UN GTR#13 IWG SGS meeting

Tianjin, 18-20 June 2019

# **GTR#13 fire test: suggested amendments**

Vladimir Molkov, Dmitriy Makarov, Sergii Kashkarov

## Ordinary tank (left) and LNB tank (right)

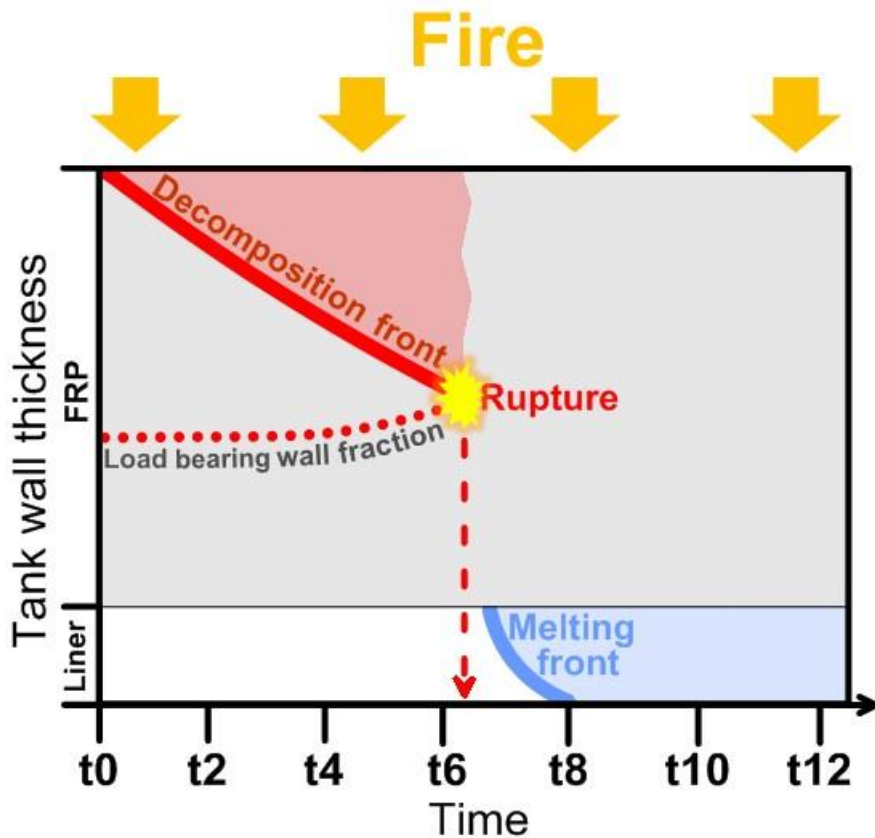
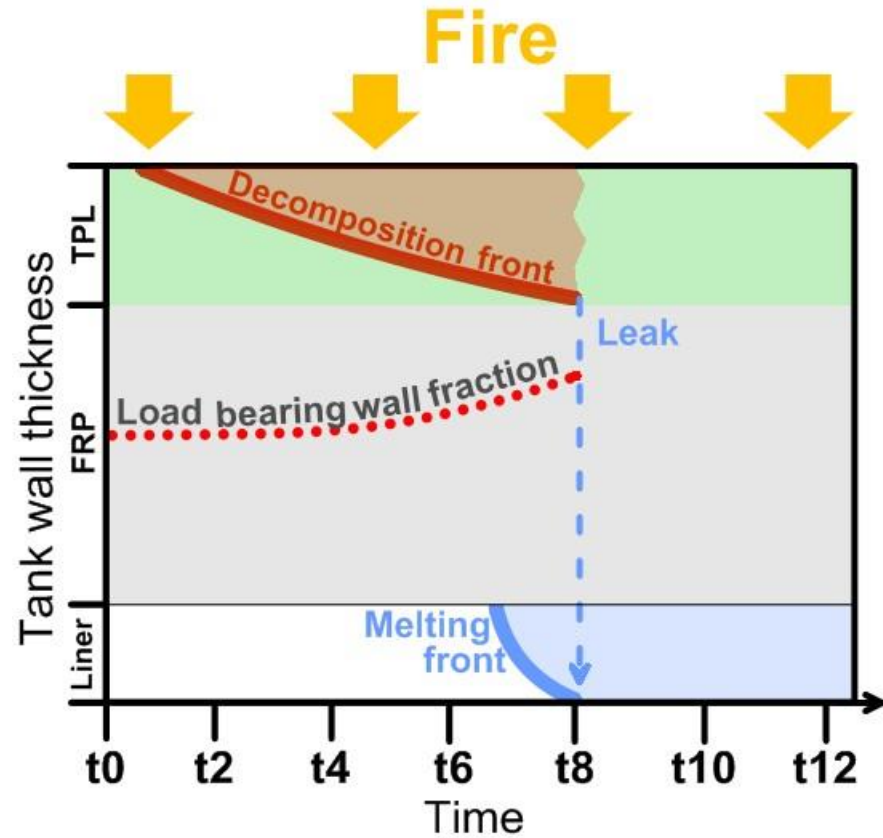
“The test unit is the compressed hydrogen storage system. The storage system is filled with compressed hydrogen gas at 100 per cent NWP. The container is positioned in direct contact with a hot metal plate mimicking temperature of a smouldering material (depends on material). The hot plate sizes should be at least of the length and width of the test article.

The hot plate surface temperatures shall be monitored by at least three thermocouples. Thermocouples temperature and the container pressure shall be recorded at least every 30 seconds during the test.”... (continued on next page)

“In the smouldering fire test without TPRD the fire resistance rating of a tank (the elapsed time from ignition of the fire to the tank rupture) should be documented.”

**This is an initial proposal for localised smouldering fire test.**
